ATB 52056 (1407)

Safety Recall: Wrong A-Pillar Trim Is Installed

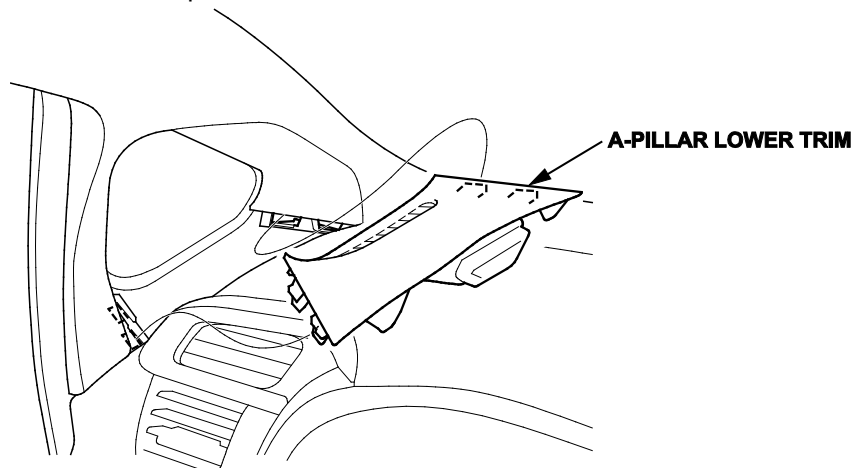
- Look for a "SIDE CURTAIN AIRBAG" stamp on the left and right A-pillar trim.
 - If the A-pillar trim has "SIDE CURTAIN AIRBAG" stamped on it, the vehicle is OK. No further action is needed.
 - If the A-pillar trim does not have "SIDE CURTAIN AIRBAG" stamped on it, go to REPAIR PROCEDURE.

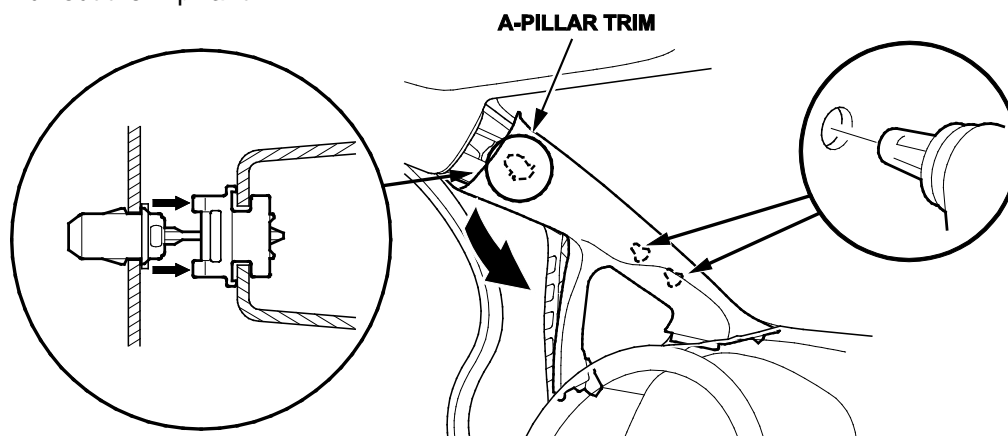
1. Remove the A-pillar lower trim.

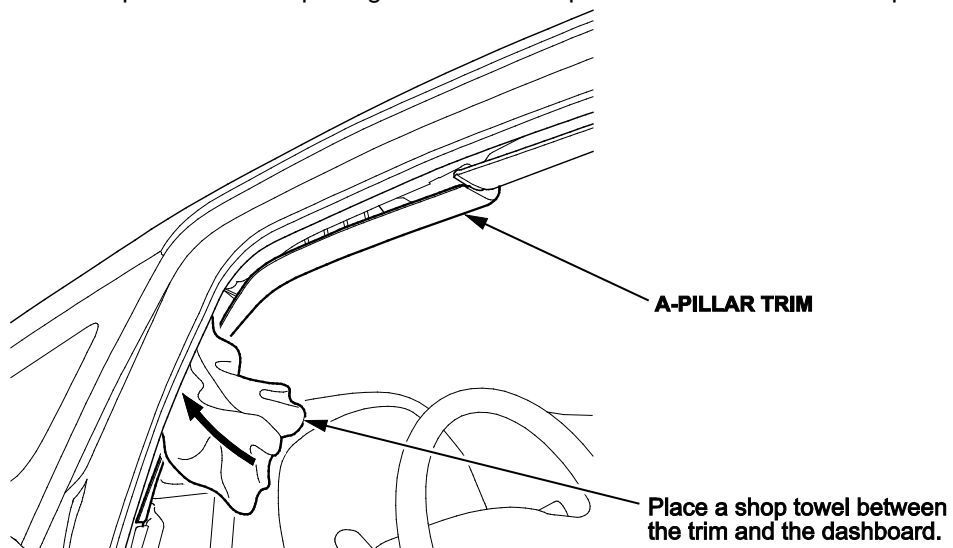
2. Pull out the A-pillar trim.

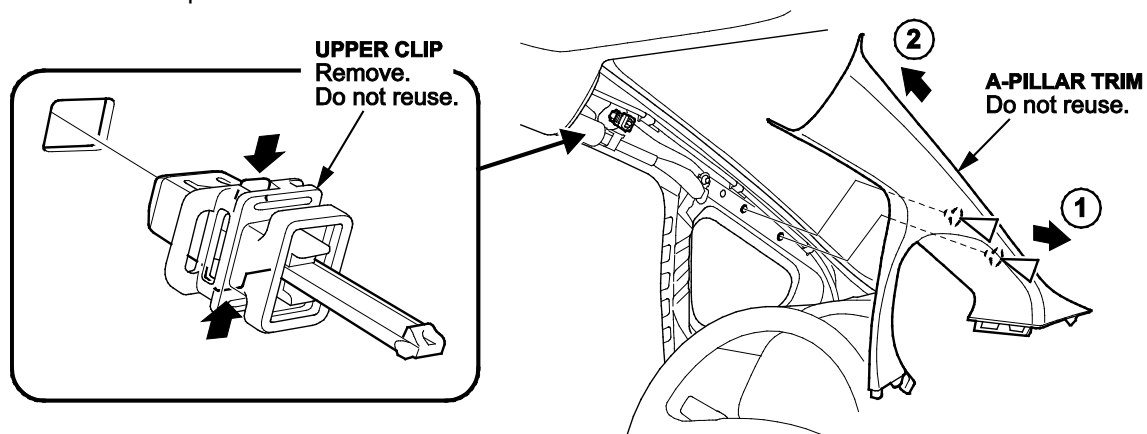
3. Put a shop towel in the opening between the A-pillar and the dashboard to prevent dropping the A-pillar clips.
